To: **Planning Reps**
From **Highways Development Management Officer**

Your Ref 20220687

Location 2 Salcote Road, Gravesend, Kent, DA12 4RB

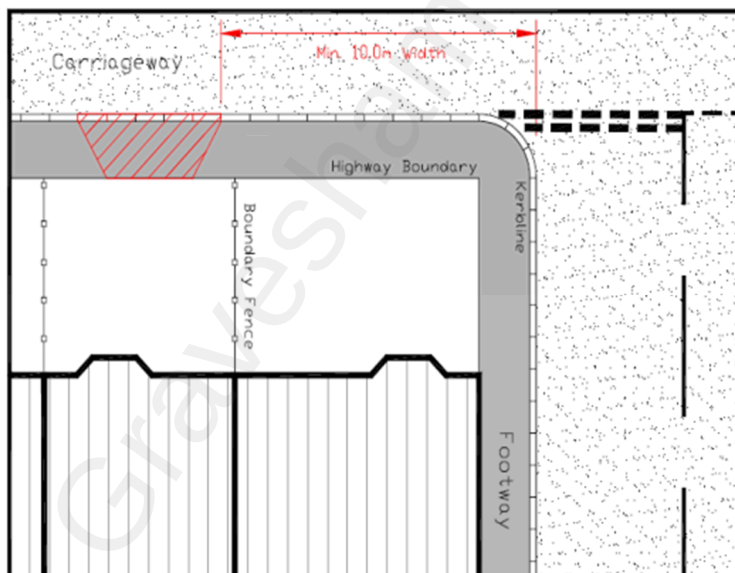
This application raises some concerns for which I do not have the answer. Any open space adjacent to the highway, irrespective of who owns the land could be public highway and have utility company or highway equipment buried in it. The applicant must confirm with Kent County Council that the land he intends to fence is indeed private with no highway rights of access.

In terms of the proposal, the property remains as a three bedroom dwelling and there appears to be little if any justification for providing two additional parking spaces, particularly when this would result in one space at least being within 10 metres of a road junction which Kent County Council consider unacceptable, as it can result in a highway hazard.

However, as presented with the car parking provision being within 10 metres of a road junction, a distance the Highway Authority, Kent County Council consider would create a hazard and the fact that there is no pedestrian visibility splay, I would recommend refusal.

Footway visibility

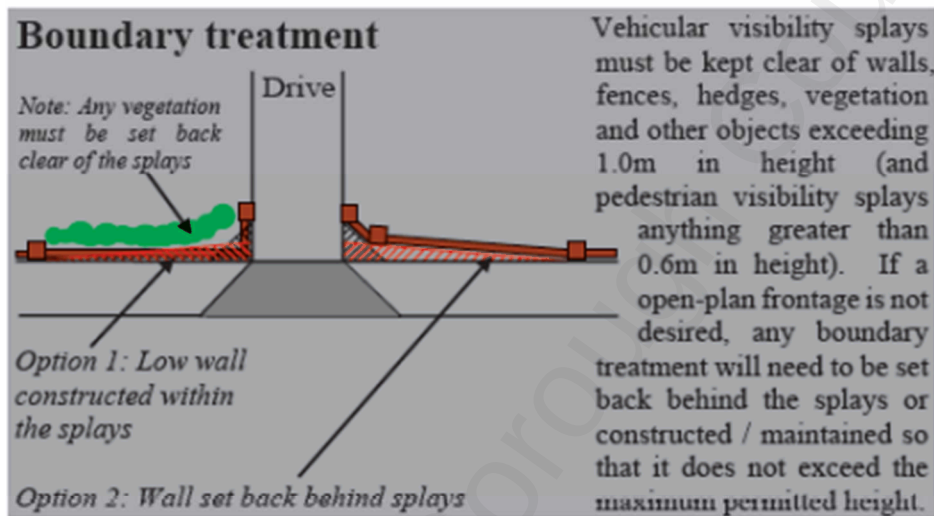
In terms of the fencing, 2m x 2m pedestrian visibility splays would be required down the side of the drive with nothing over 850mm in height within the splay.

There should be no obstruction to visibility between heights of 0.85m and 2.0m above footway level. If the footway is likely to be used by small children, the height should be reduced to 0.6m. Where all or part of the splay lies across land outside of the applicant's control, a relaxation to this requirement may be considered, taking into account the amount of pedestrian activity along the footway and the width of the footway.
